## 7.0 Instrumentation and Control Systems

### 7.1 Introduction

The information in this section of the reference ABWR DCD, including all subsections and tables, and figures, is incorporated by reference with the following departures and supplements.

Figure 7.1-1 SSLC Self-Test System

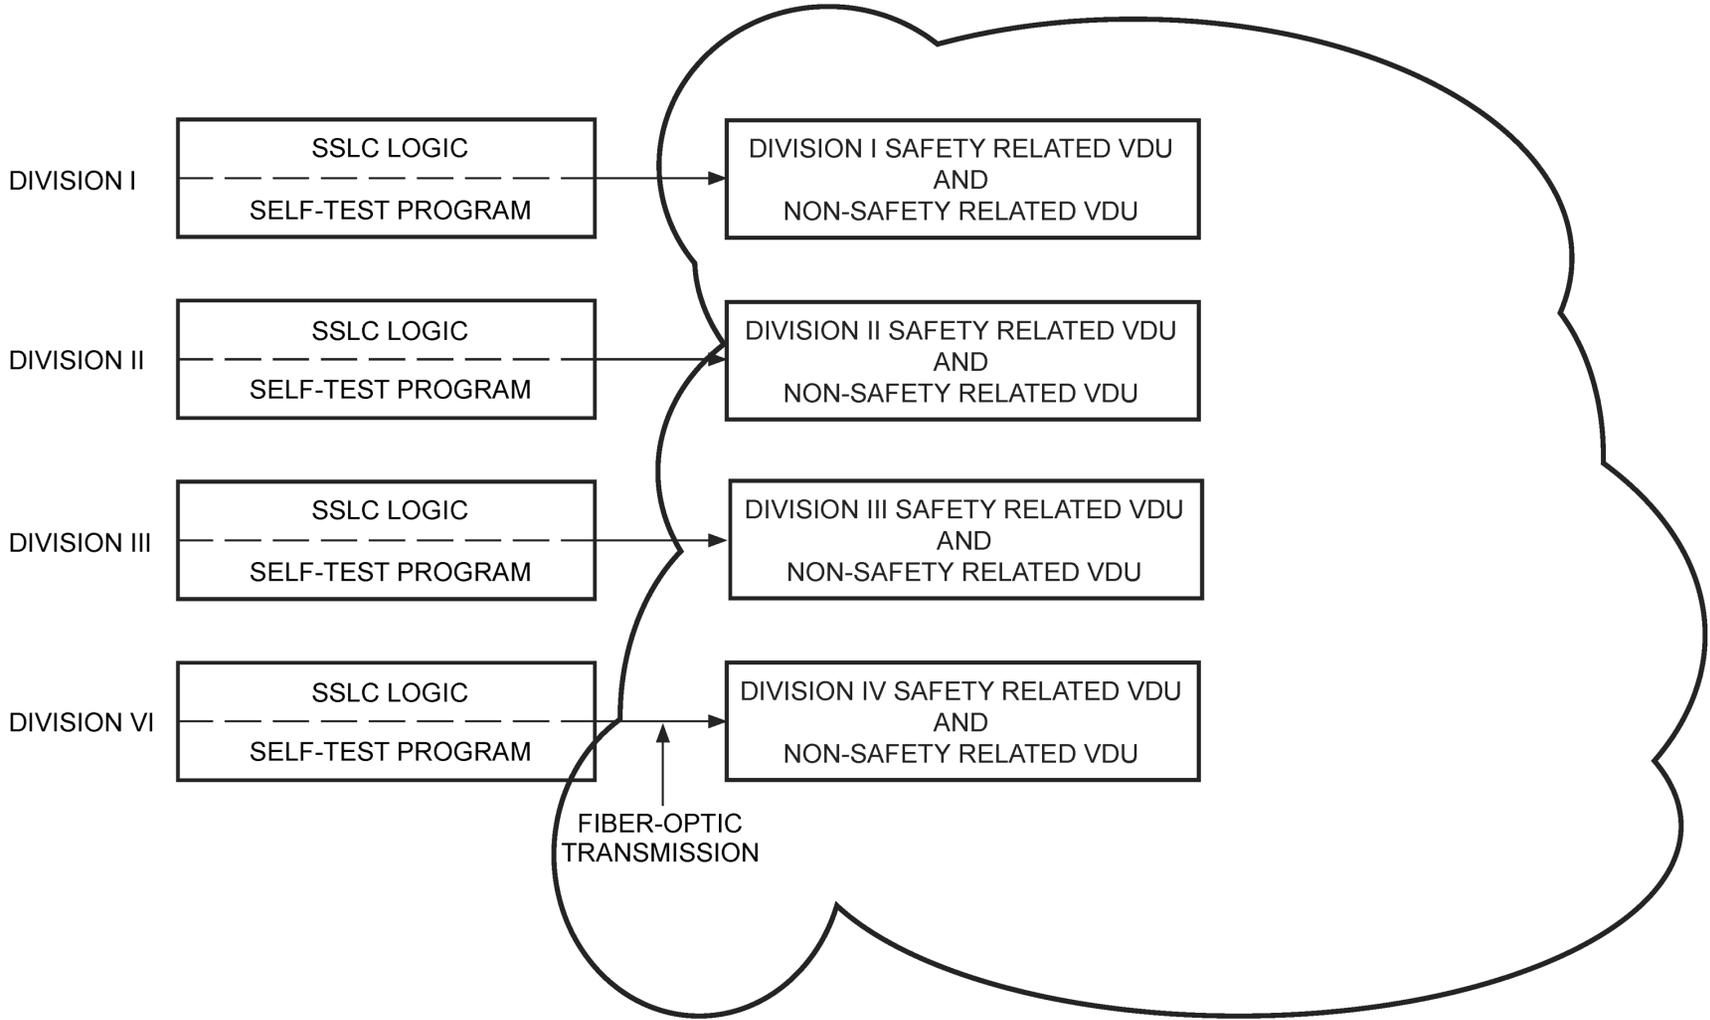
STD DEP T1 3.4-1 (Figure 7.1-1, 7.1-2)

STD DEP T1 3.4-1

*Divisional separation is also applied to the ~~essential multiplexing system (EMS)~~ Essential Communication Function (ECF) for Safety System Logic and Control (SSLC), which provides data highways for the sensor input to the logic units and for the logic output to the system actuators (actuated devices such as pump motors and motor-operated valves). Systems which utilize the SSLC are: (1) Reactor Protection (trip) System; (2) High Pressure Core Flooder System; (3) Residual Heat Removal System; (4) Automatic Depressurization System; (5) Leak Detection and Isolation System; (6) Suppression Pool Monitoring System; and (7) Reactor Core Isolation Cooling System. The equipment arrangement for these systems and other supporting systems is shown in Figure 7.1-2.*
